NUCLEAR REGULATORY COMMISSION

Title: Advisory Committee on Reactor Safeguards
New Reactors Subcommittee
Open Meeting

Date: Tuesday, September 15, 2026

Figure 7. Analytical and experimental results of the reactor power transient in the LOFC test at 9 MW.

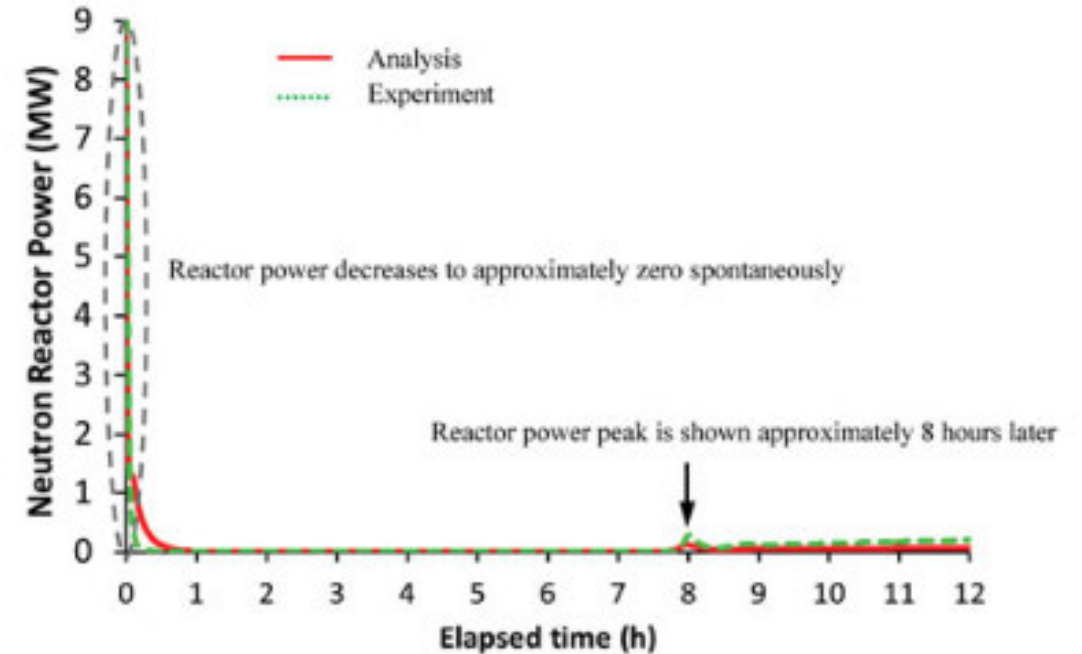
10 MEMBER PETTI: Juan, just a question, a
11 comment here, right? That analysis not -- is not your
12 analysis. That's JAEA's analysis, I assume?

13 MR. ARELLANO: That's correct.

Figure 27: Fission Reactor power during DLOFC event

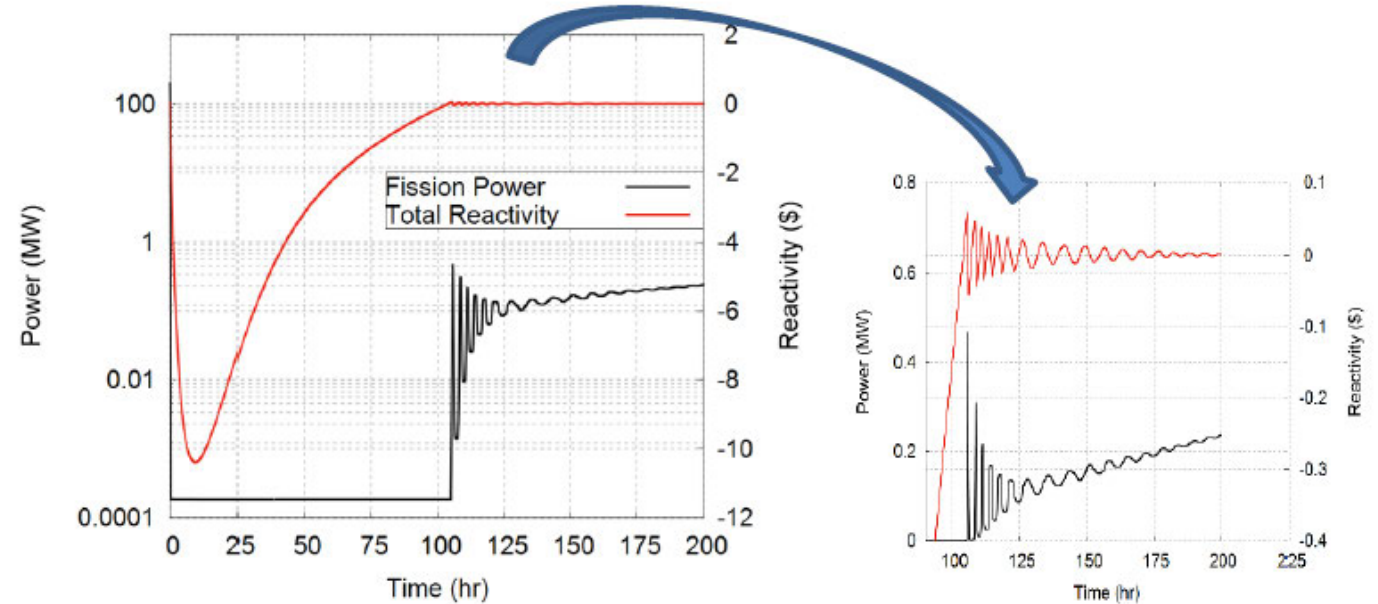
1 cooling and no rods being inserted. And you can see
2 here it also shuts down relatively quickly on inherent
3 reactivity feedback alone. Then at about 108 hours,
4 we go recritical, and it begins oscillating. But if
5 you were to extend the graph out, you would see it
6 would level out, become steady, which, again, we are
7 extending that analysis this fall to show that.

RCCS Passive System Overview: SFA

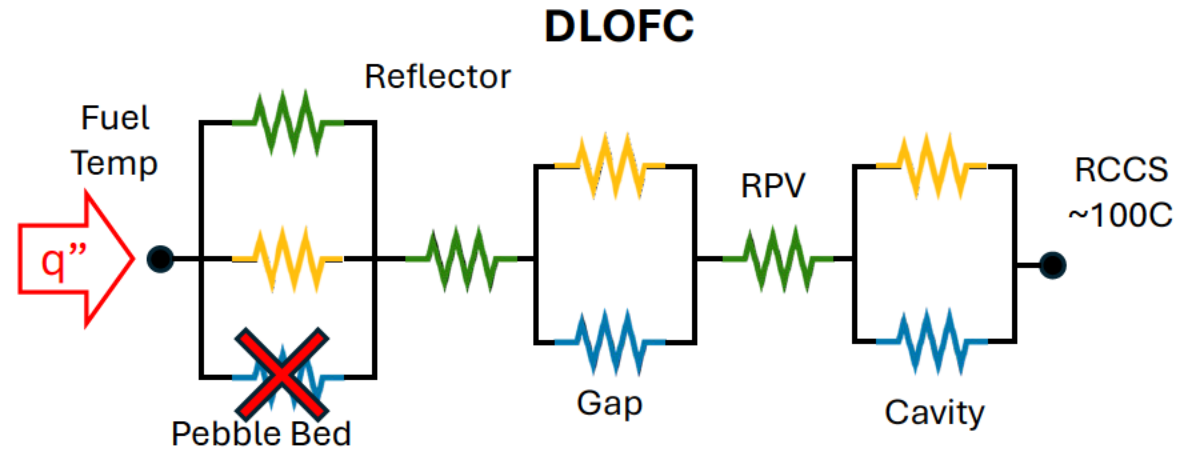
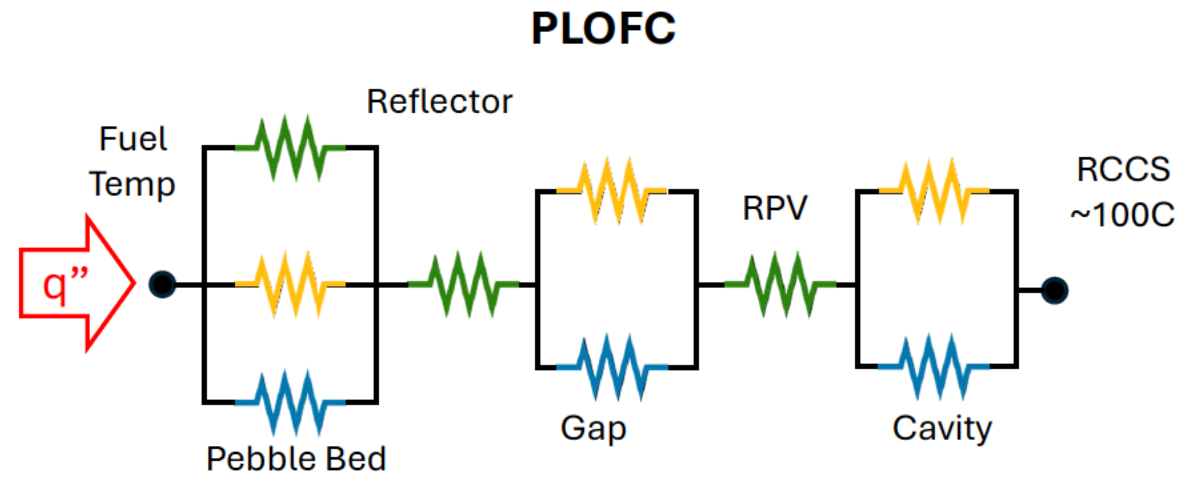
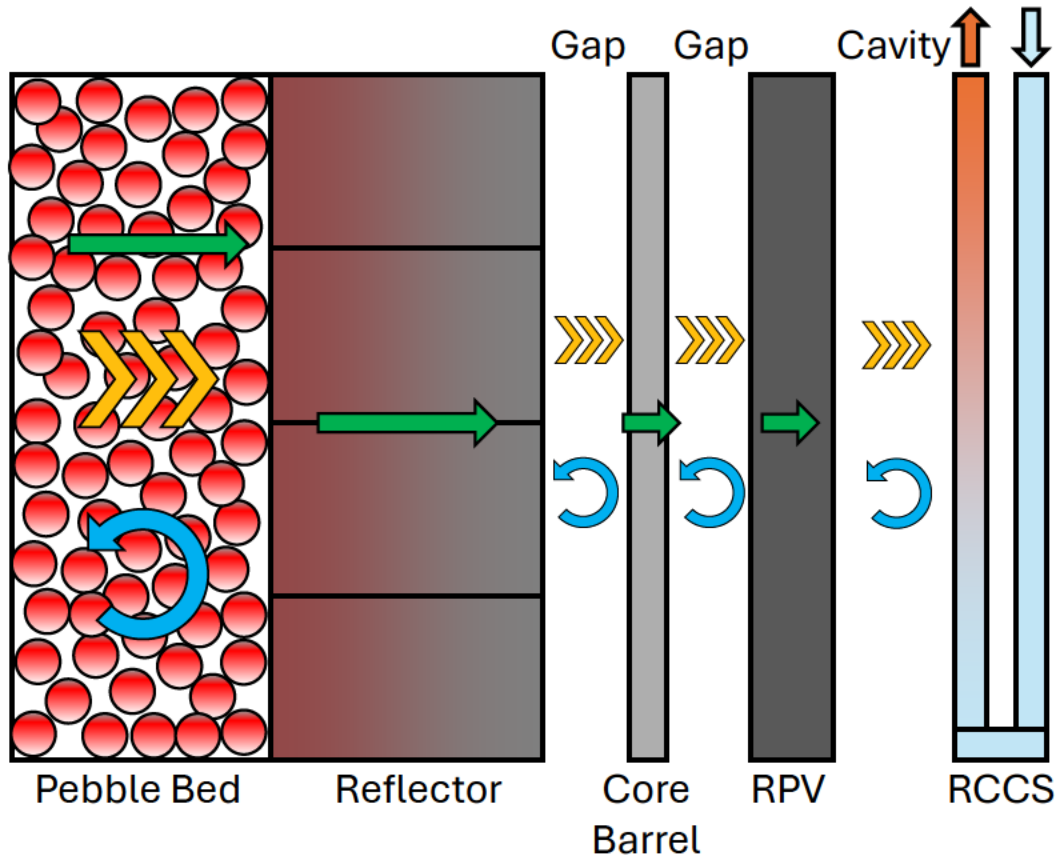
1 intending to err on the side of conservatism, because
2 you've not done tests, right? Not specific tests for
3 yourselves. But there are tests. We've mentioned
4 before the work done in Argonne. Are these phenomena
5 that had been observed in those tests. You know, I'm
6 just looking maybe at the first one, the steam
7 separation comment there. Where do you draw on these
8 hypothetical type concerns?

20 MEMBER PALMTAG: So, slide here is really
21 reflecting my question earlier, right? About the
22 geyser and basically instabilities --

3 MR. SCHINNER: Yep. So this slide is
4 addressing the instability question that came up from
5 the ACRS members. So the instabilities that were
6 brought up, we are looking at, and they're mainly the
7 steam separation within the riser header, potential
8 geysering, parallel channel instability. These are
9 all kind of the phenomena that happen in the water as
10 it begins to reach saturation temperature. We are
11 looking at these in a lot more detail, and we will
12 address these as the design progresses, mostly
13 designing them out of it or ensuring that these
14 instabilities do not challenge our required safety
15 functions. Most of these are through kind of
16 structural evaluations. The geysering could have a
17 lot of pressure waves, pressure surges that we want to
18 make sure we fully capture, that our system is
19 designed to handle that, or design it out so that
20 wouldn't affect the design.

13 MR. SCHINNER: Yes. The primary data is
14 from where the tests are from Argonne National Labs
15 and SDF facility. And they noticed the geyser
16 phenomena in their upper plenum tube back to the tank,
17 so that's the main thing we're drawing from. But also
18 we're doing additional work with like RELAP5 to kind
19 of look at these instabilities and quantify them.

Limiting Scenarios

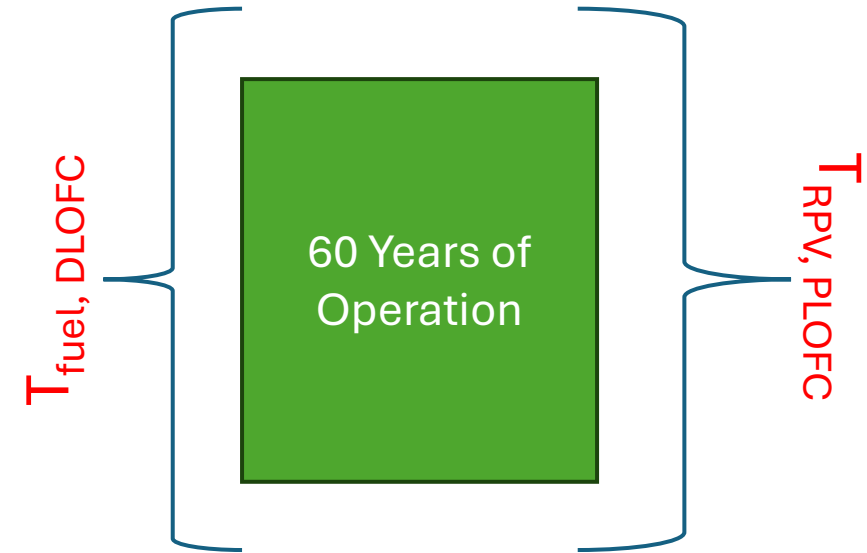
20 MEMBER PETTI: Yeah, no, that was my
21 question. I understood the logic. It was more on the
22 RPV temperature. It says including uncertainties. It
23 seemed to me you'd want to do a case where you recover
24 all the radiation damage, you anneal out it during the
25 DLOFC or the PLOFC and you move a heck of a lot of

6 MR. BALESTRA: Yes. Obviously the safety
7 analysis that we have done focus on the fuel
8 temperature, right? So because we use the fuel
9 temperature for the dose calculations for the -- and
10 that was the main focus for the CPA. We use end of
11 life graphite conductivities and we also add
12 conservatism also artificially reducing that graphite
13 conductivity to take into account the uncertainties.
14 That inevitably produces milder temperatures on the
15 RPV, but that's to maximize the fuel temperature.
16 Dedicated studies will be done to maximize the
17 temperature of the RPV. Obviously, we cannot maximize
18 both in the same calculation. So that's the theory.
